KWM-380 TRANSCEIVER (622-5093-101)  
HF-380 TRANSCEIVER (622-3580-101)  
RECEIVER-EXCITER CIRCUIT CARD A3 (638-6908-001)

SERVICE BULLETIN NO 1

PRODUCT IMPROVEMENT

Figure 1

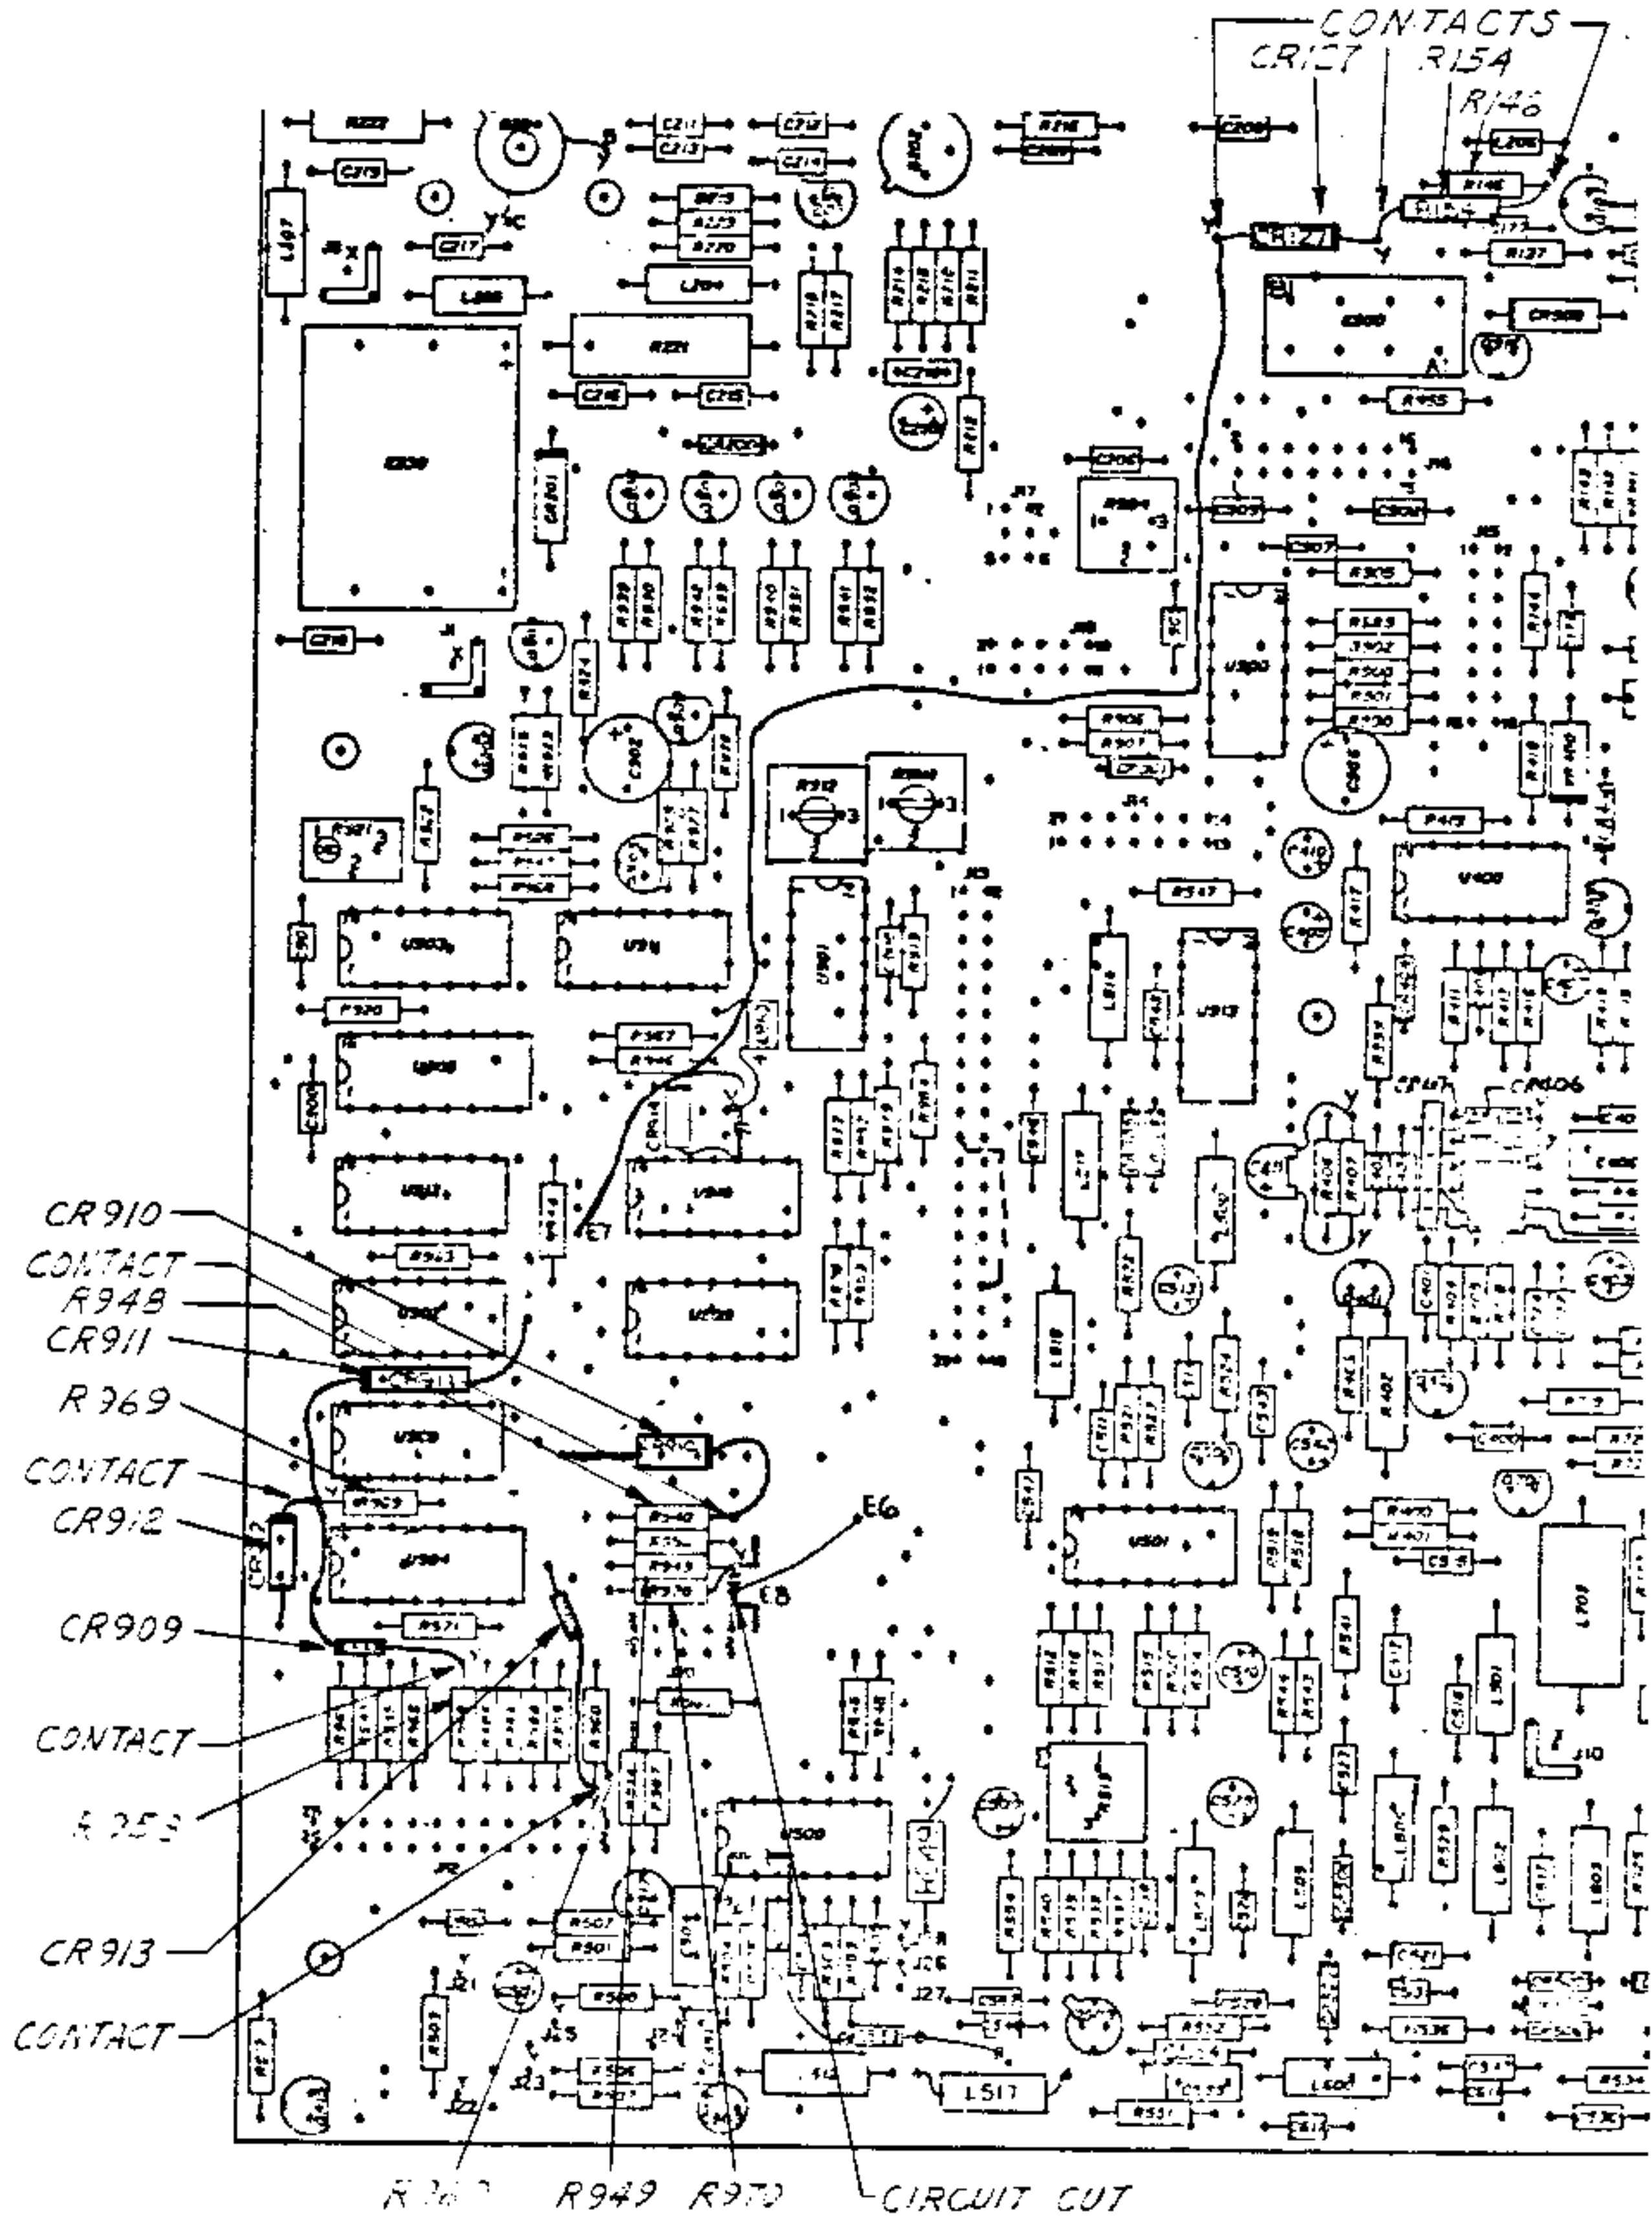
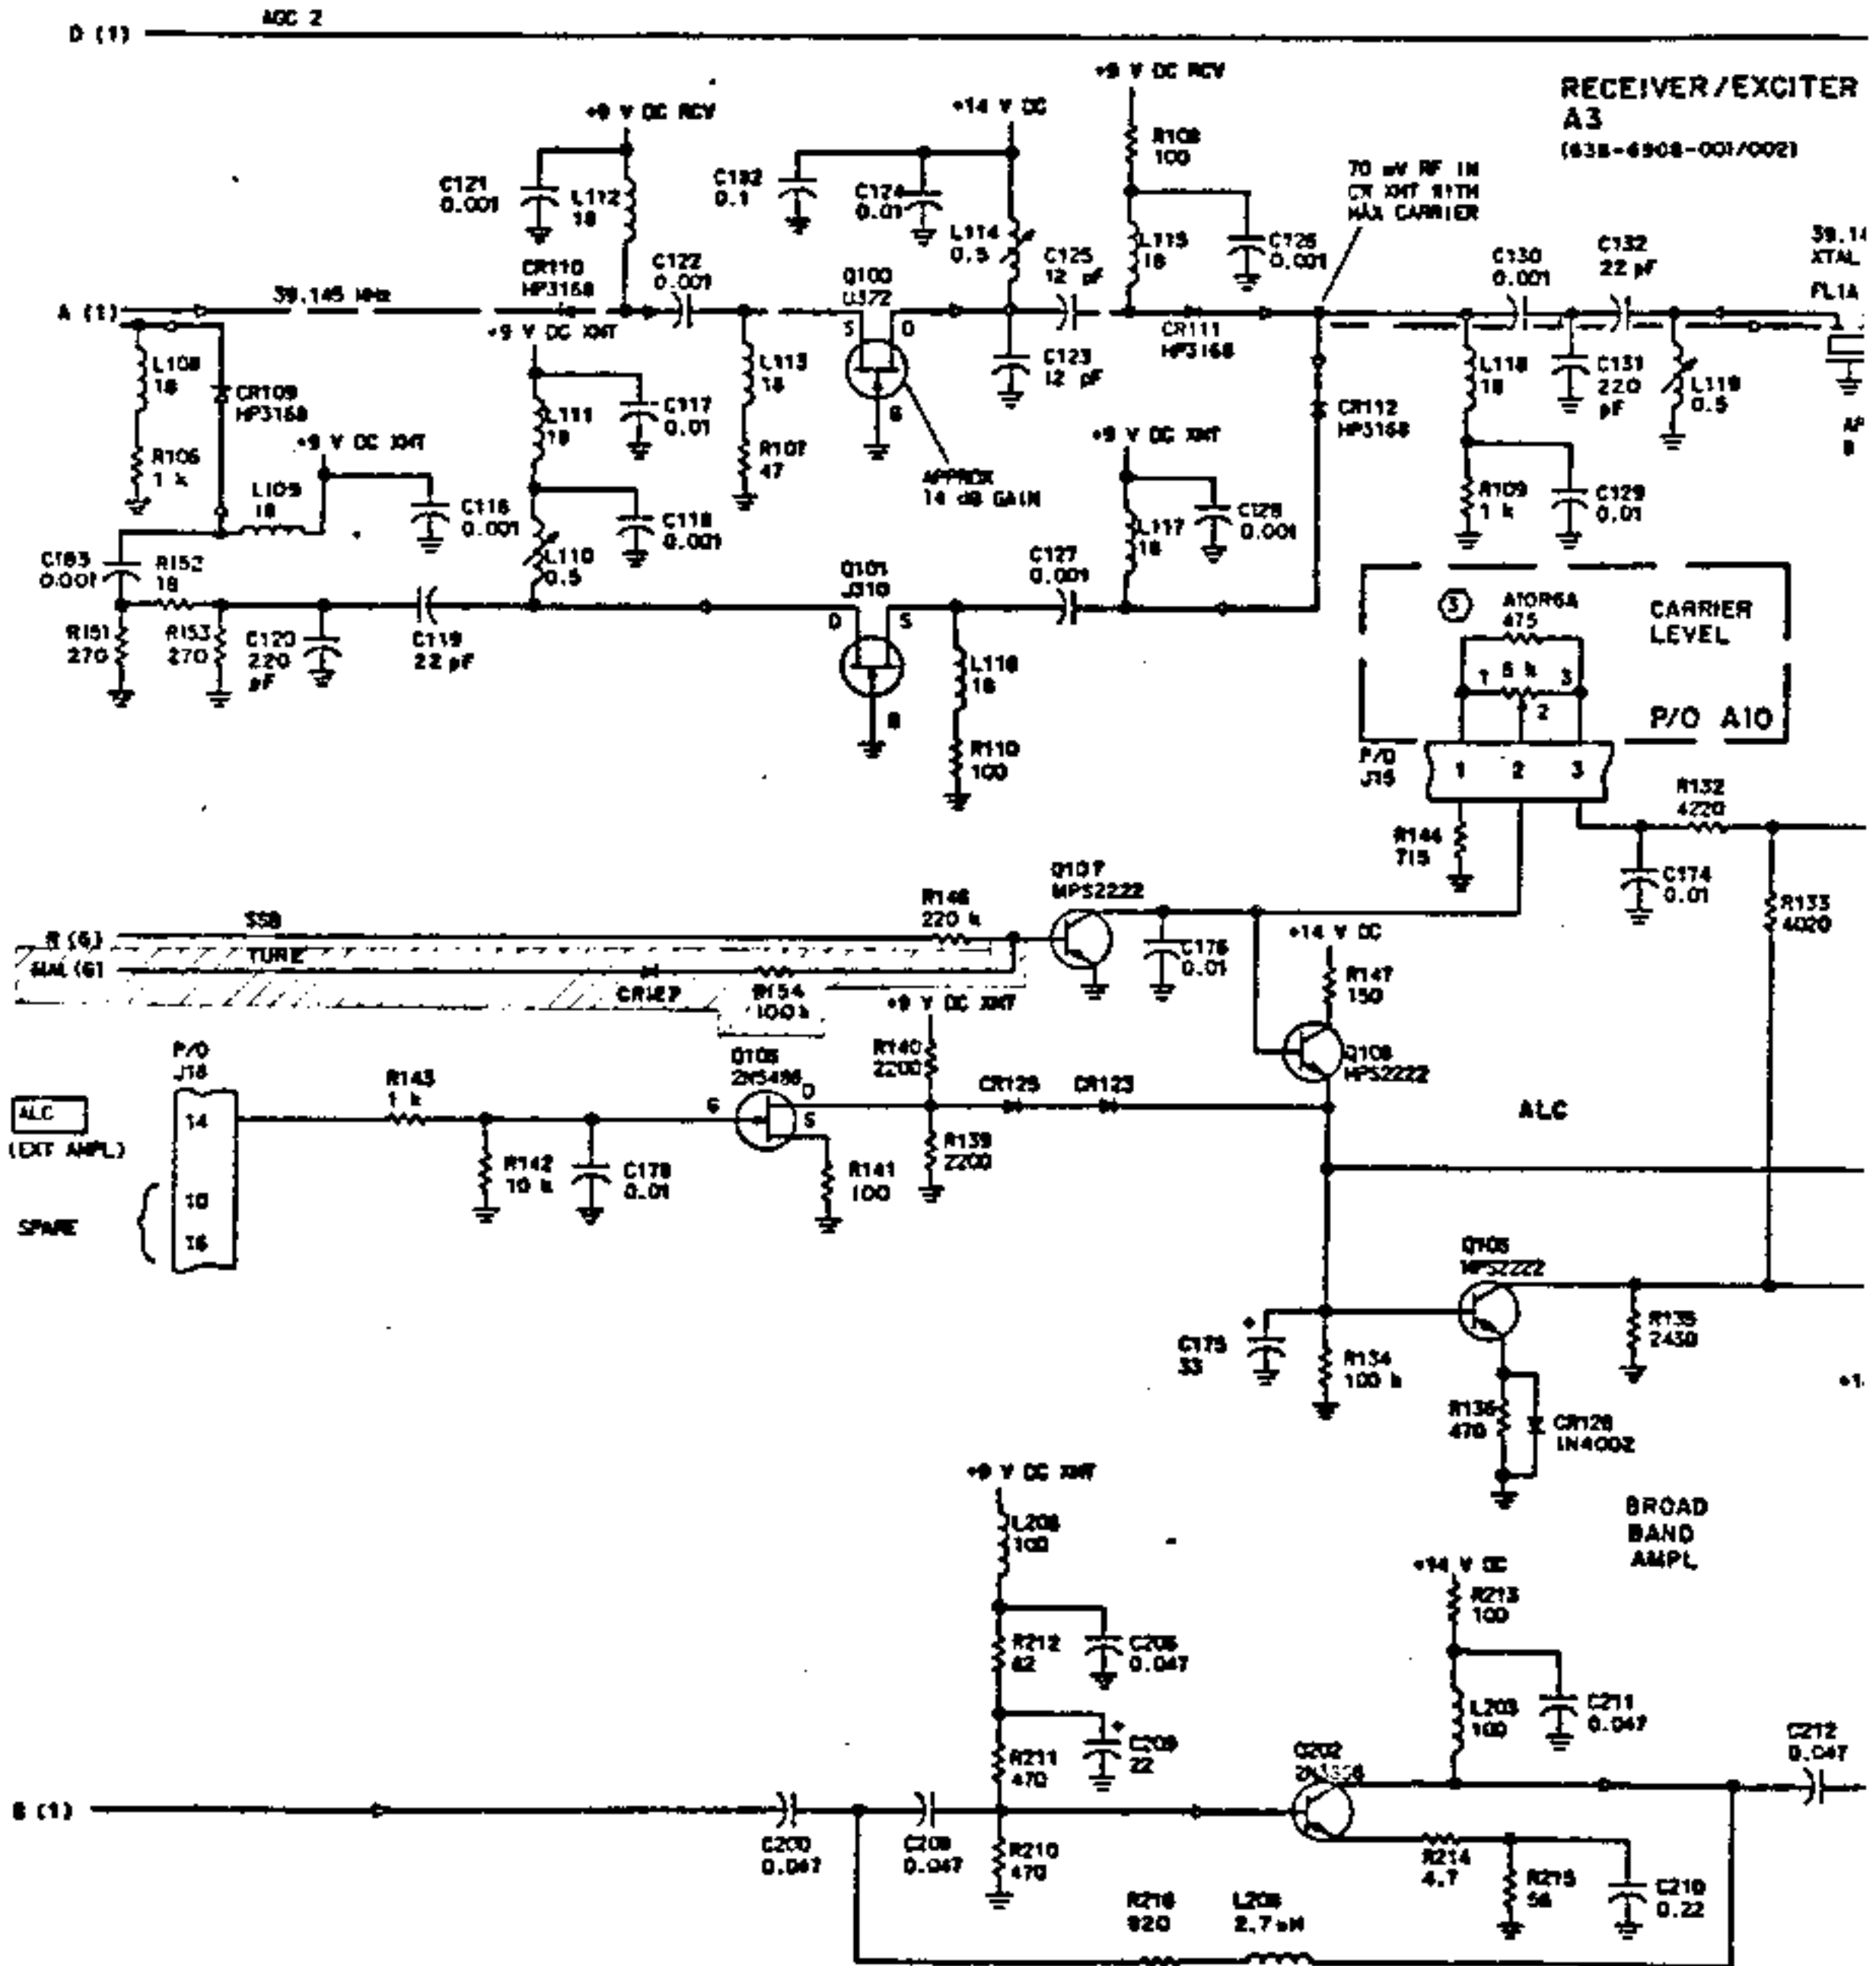
- D. Cut the circuit trace that connects R970 and R949 right-hand leads as shown in figure 1. Cover the circuit trace cut with a nonconductive material such as epoxy.

- H. Install and solder a #30 AWG jumper wire (428-0282-050) from E8 to E6 as shown in figure 1.

- K. Connect the R960 lead to the new contact.
- L. Install 1N4454 diode CR913 (353-3644-010) as shown in figure 1 with the cathode end connected to the contact installed in step J. Solder connections on both ends.

- Q. Install 1N4454 diodes CR911 and CR912 (353-3644-010) as shown in figure 1 with the cathodes connected to R969. Solder all connections.
- R. Unsolder and lift the right-hand lead of resistor R948.

- S. Install and solder a contact (372-2601-045) in the hole where the R948 lead was removed.
- T. Connect the R948 lead to the new contact.
- U. Install 1N4454 diode CR910 (353-3644-010) as shown in figure 1 with the cathode end connected to the contact installed in step S. Solder all connections.

- V. Unsolder and lift the right-hand lead of resistor R146.
- W. Install and solder three contacts (372-2601-045) in the vicinity of R146 as shown in figure 1.

- X. Connect the R146 lead to one of the new contacts as shown in figure 1.
- Y. Install 100-k $\Omega$  resistor R154 (745-0821-000) between two of the new contacts as shown in figure 1.

- Z. Install 1N4454 diode CR127 (353-3644-010) as shown in figure 1 with the cathode end connected to R154.
- AA. Install a #30 AWG jumper wire (428-0282-050) from E7 to the anode end of CR127. Solder all connections.
